Change No. 29
License No. DPR-23

CHANGE NO. 29 TO THE TECHNICAL SPECIFICATIONS

H. B. ROBINSON PLANT UNIT NO. 2

DOCKET NO. 50-261

STEAM GENERATOR LEAKRATE LIMIT

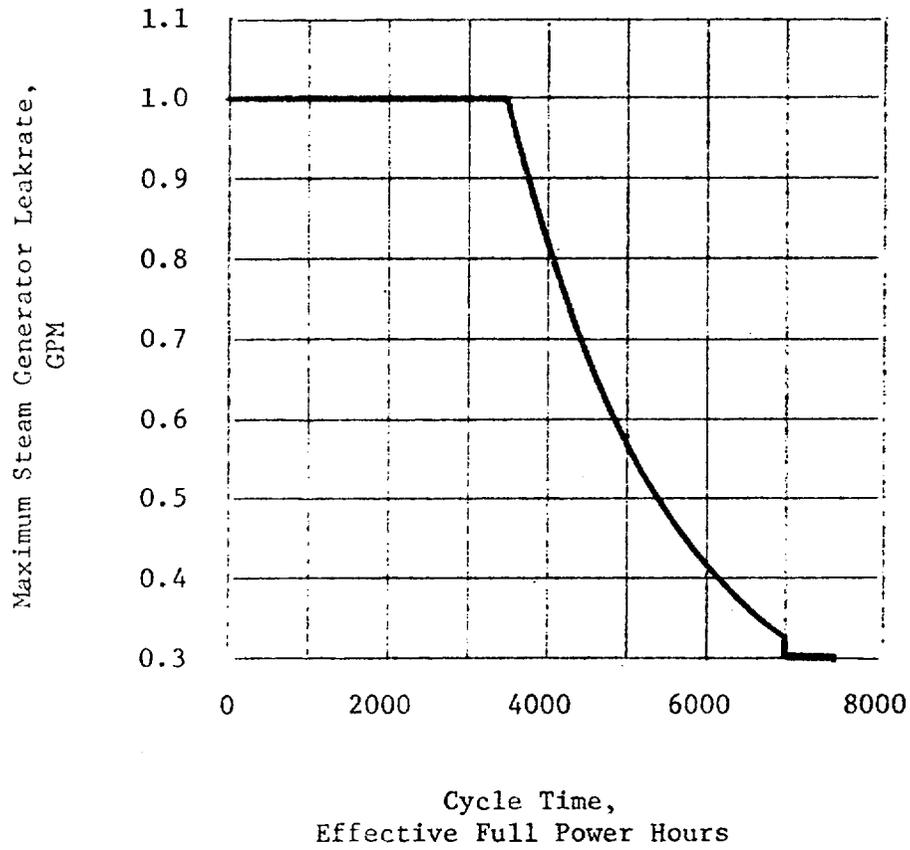
Carolina Power and Light Company has proposed a limiting maximum steam generator leakage rate of 0.3 gpm during operation in excess of 7000 EFPH. This limit on allowable steam generator leakage results from consideration of the increased number of collapsed rods that may occur due to the increased fuel cycle period and the percentage of collapsed rods assumed to fail in a postulated steam line break accident or overpower transient.

Carolina Power and Light Company has proposed a limiting maximum steam generator leakage rate of 0.3 gpm during operation in excess of 7000 EFPH. This limit on allowable steam generator leakage results from consideration of the increased number of collapsed rods that may occur due to the increased fuel cycle period and the percentage of collapsed rods assumed to fail in a postulated steam line break accident or overpower transient.
